Site Accessibility Evaluation

**Community Development
630 Garden St
Santa Barbara, CA 93101
Accessibility Evaluation
Inspection Date: 08/16/2023
Inspectors: Scott Saddlemire**

Report Date: 11/03/2023

Finding: 4

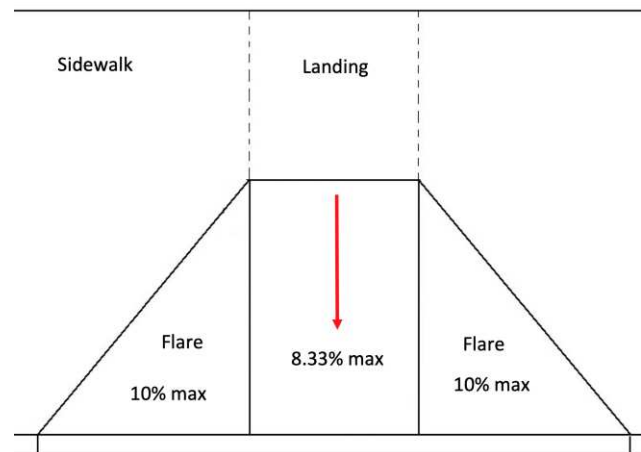
The curb ramp exceeds the maximum running slope (parallel to the direction of travel) allowable of 8.33%.

Curb ramps should have the least possible slope but in no case more than 8.33% (1:12).

N/A - Refer to Finding

Parking: Entrance**Finding: 13**

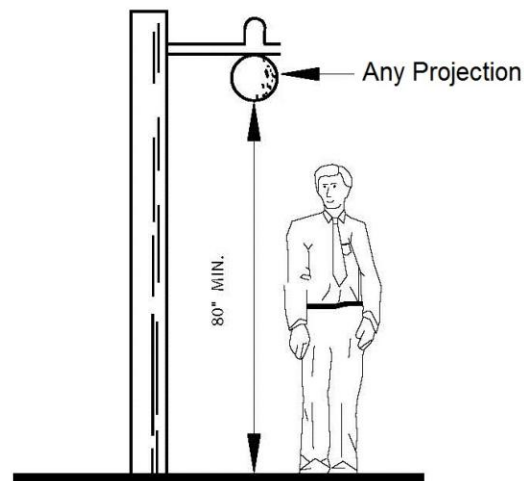
The element extends down too close to the route of travel.

Any obstruction that overhangs a route of travel must be a minimum of 80 inches above the walking surface as measured to the bottom of the obstruction.

N/A - Refer to Finding

Parking: Entrance**Finding: 14**

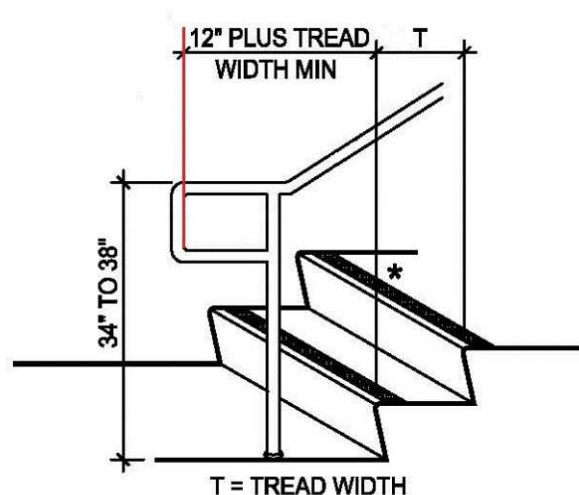
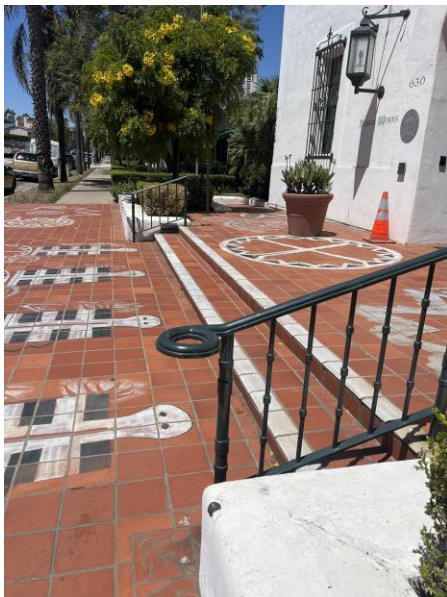
The handrail does not have a compliant extension at the bottom of the stair flight.

At the bottom of a stair flight, handrails shall extend at the slope of the stair flight for a horizontal distance equal to one tread depth beyond the last riser nosing. The horizontal extension of a handrail (not including the curved portion of round handrails) shall be 12 inches long minimum and a height equal to that of the sloping portion of the handrail as measured above the stair nosings. Extension shall return to a wall, guard, or the landing surface, or shall be continuous to the handrail of an adjacent stair flight.

SSA

Full length of extension must be
HORIZONTAL

Finding: 16

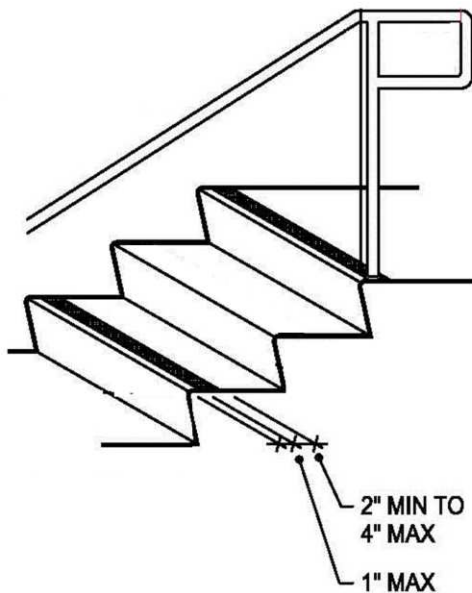
The stripe is more than 4 inches from the edge of the nosing and/or upper approach.

The stripe shall be a minimum of 2 inches wide to a maximum of 4 inches wide placed parallel to, and not more than 1 inch from, the nose of the step or upper approach. The stripe shall extend the full width of the step or upper approach and shall be of material that is at least as slip resistant as the other treads of the stair. A painted stripe shall be acceptable. Grooves shall not be used to satisfy this requirement.

N/A - Refer to Finding

Finding: 18

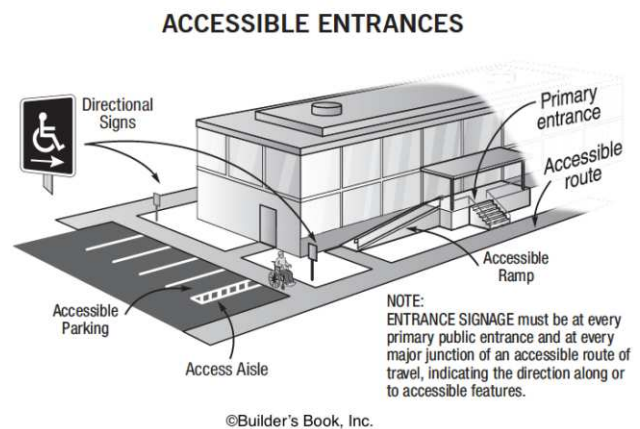
There is no accessible route to the accessible element.

At least one accessible route shall connect accessible buildings, accessible facilities, accessible elements, and accessible spaces that are on the same site.

No accessible route to element

Parking: Entrance**Finding: 20**

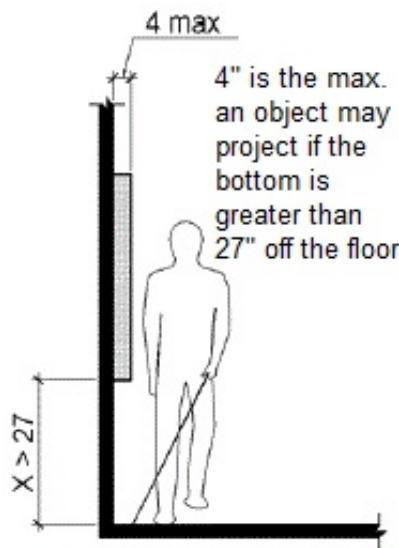
The element projects more than 4 inches into the circulation path.

Wall-mounted objects that have leading edges between 27 inches and 80 inches from the floor must not project more than 4 inches into the circulation path. Protruding objects that extend to the floor or within 27 inches of the floor are cane detectable and are therefore not hazardous. Where it is necessary or desirable to have objects protrude from the wall, a manner of cane detection must be provided.

N/A - Refer to Finding

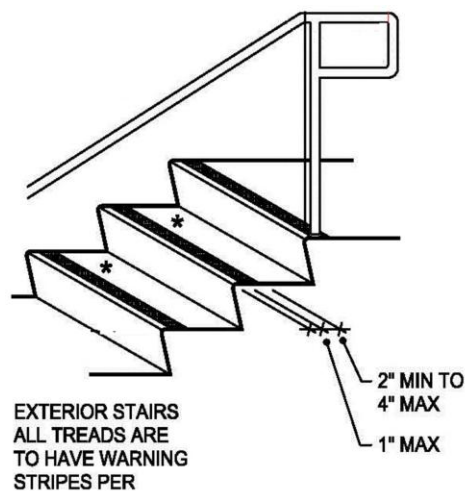
Interior stairs shall have the upper approach and lower tread marked by a stripe providing clear visual contrast. Exterior stairs shall have the upper approach and all treads marked by a stripe providing clear visual contrast. The stripe shall be a minimum of 2 inches (51 mm) wide to a maximum of 4 inches (102 mm) wide placed parallel to, and not more than 1 inch (25 mm) from, the nose of the step or upper approach. The stripe shall extend the full width of the step or upper approach and shall be of material that is at least as slip resistant as the other treads of the stair. A painted stripe shall be acceptable. Grooves shall not be used to satisfy this requirement.

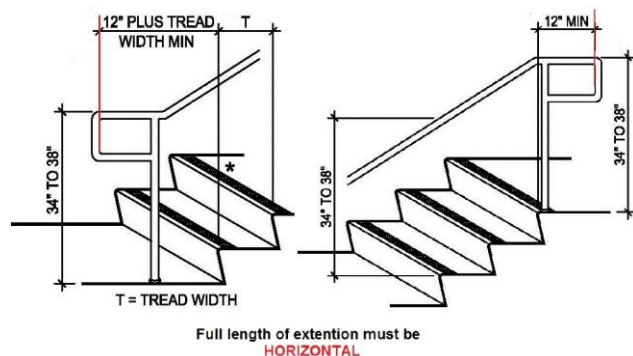
Handrails shall be provided on both sides of stairs and ramps.

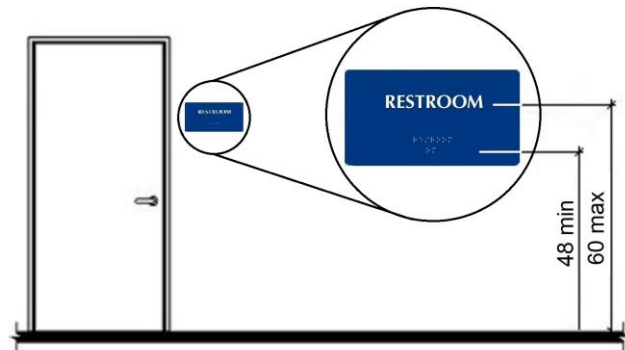
Interior and exterior signs identifying permanent rooms and spaces shall comply with Sections 11B-703.1, 11B-703.2, 11B-703.3 and 11B-703.5. Where pictograms are provided as designations of permanent rooms and spaces, the pictograms shall comply with Section 11B- 103.6 and shall have text descriptors complying with Sections 11B-703.2 and 11B-703.5.

possibly add employee only
signs

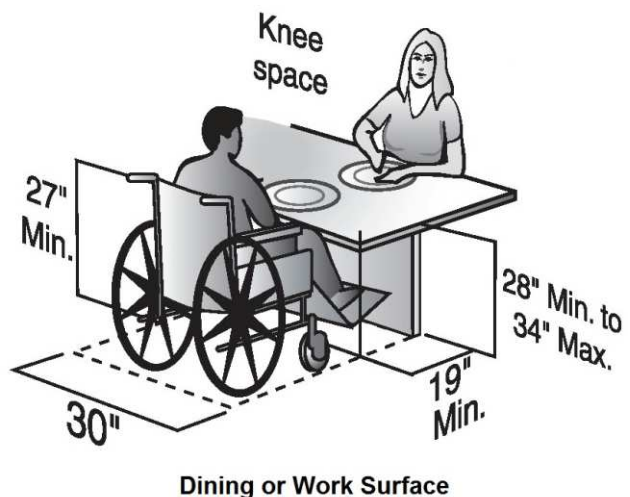
Where space beneath an element is included as part of clear floor or ground space or turning space, the space shall comply with Section 11 B-306. Additional space shall not be prohibited beneath an element but shall not be considered as part of the clear floor or ground space or turning space.

this table appear to have a
specific use and does not
provide knee space

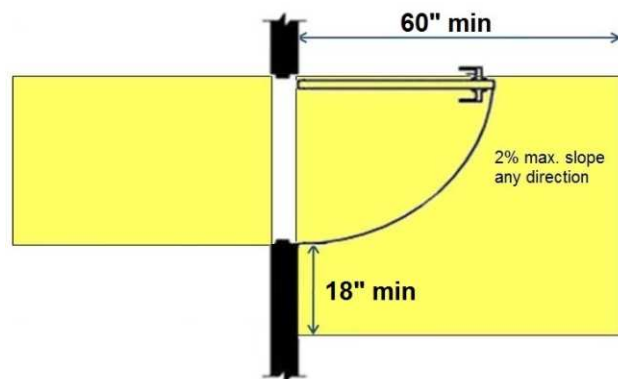
obstructed

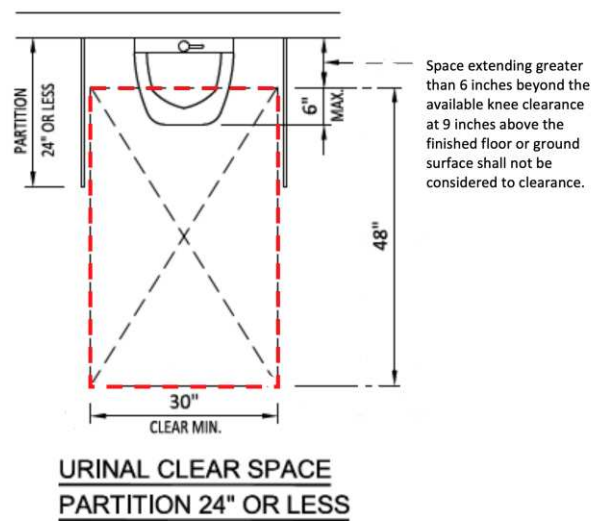
The urinal is located in an area that does not provide the required clear floor space for a front approach.

The surrounding elements of a urinal must provide a minimum of 30 by 48 inches of clear floor space for a front approach.

protruding object
